Planning Commission Agenda

Site Plan Review

Site: 26600 Southfield Road
Applicant: BD & E Group, LLC
Plan Date: December 30, 2024
Zoning: MX Mixed Use District
Parcel ID: 24-24-104-033
Proposal: Interior / Exterior Commercial Building Renovation

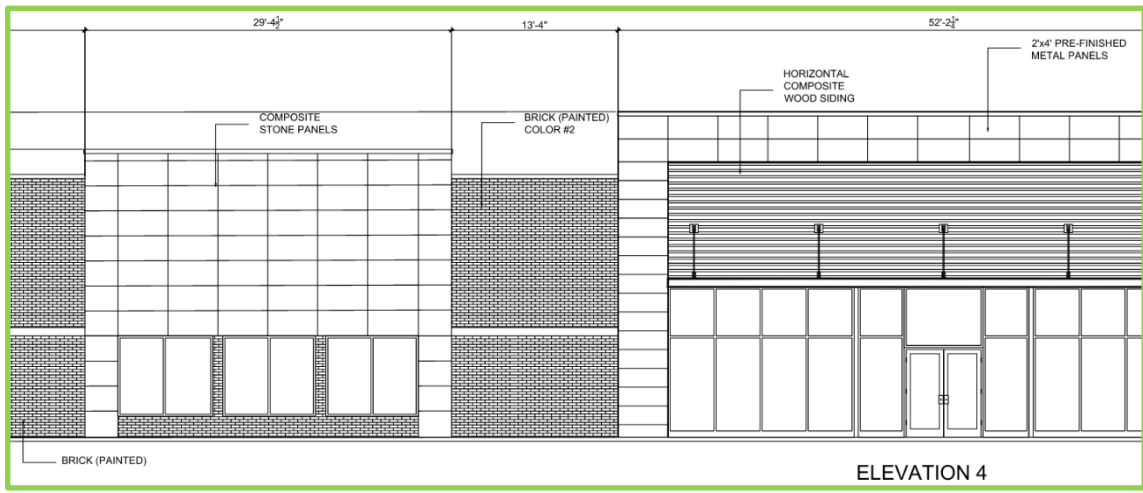
A site plan notation states the site does not generate much trash and all items delivered in boxes are either shipped or sold in the same package. The business will utilize the approved curbside waste service per the City of Lathrup Village standards. The site plan does not indicate the location of the waste receptacles; however, the image at right indicates a line of bins where the delivery door will be located, could be relocated to the south side of the building in a similar manner. This standard appears to comply (5.3.1.).

ELEVATION 4

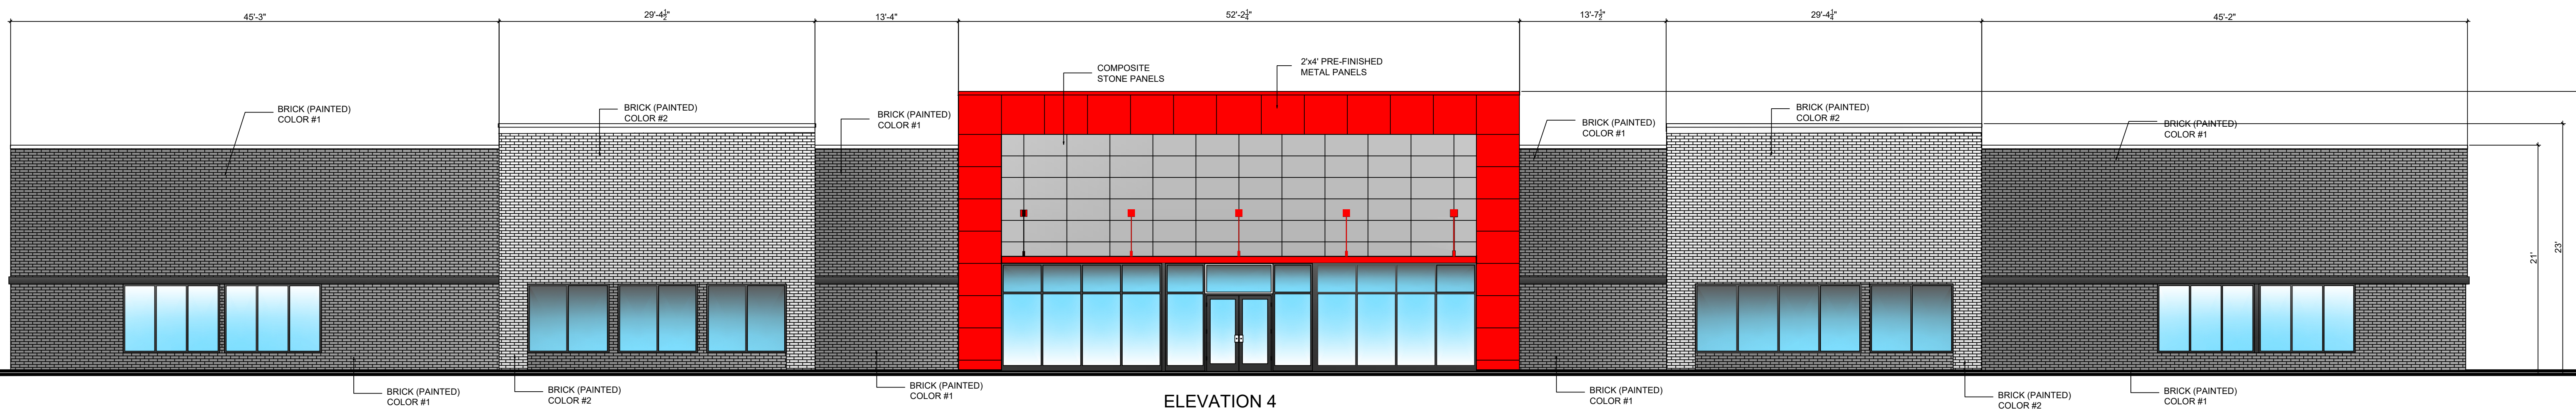
Review of the updated plan estimates the metal panels have been reduced to approximately 7.42% of the overall front façade. Additionally, about 400 square feet of composite wood siding is shown above the midsection of the building, as partially seen in the graphic below. Wood is also a trim material that is limited to 10% of the façade. When combined with the metal panels, about 15.3% of the front of the building is metal or wood siding. The remaining materials shown to be used on the building include:

- Painted brick:.....about 45.45%
- Composite stone panels:.....about 18.54%
- Glass/transparent panels:.....about 18.12%

The applicant has been notified of the determination that use of the restricted materials continues to exceed the maximum allowed by the ordinance. Additionally, the applicant has been asked to confirm the proposed color palate of the building. We anticipate the applicant to be present at the January 21, 2025 meeting to discuss the updates to the project with the Planning Commission. As previously stated, the applicant may consider providing samples of the proposed materials for the Planning Commission to discuss with the applicant.
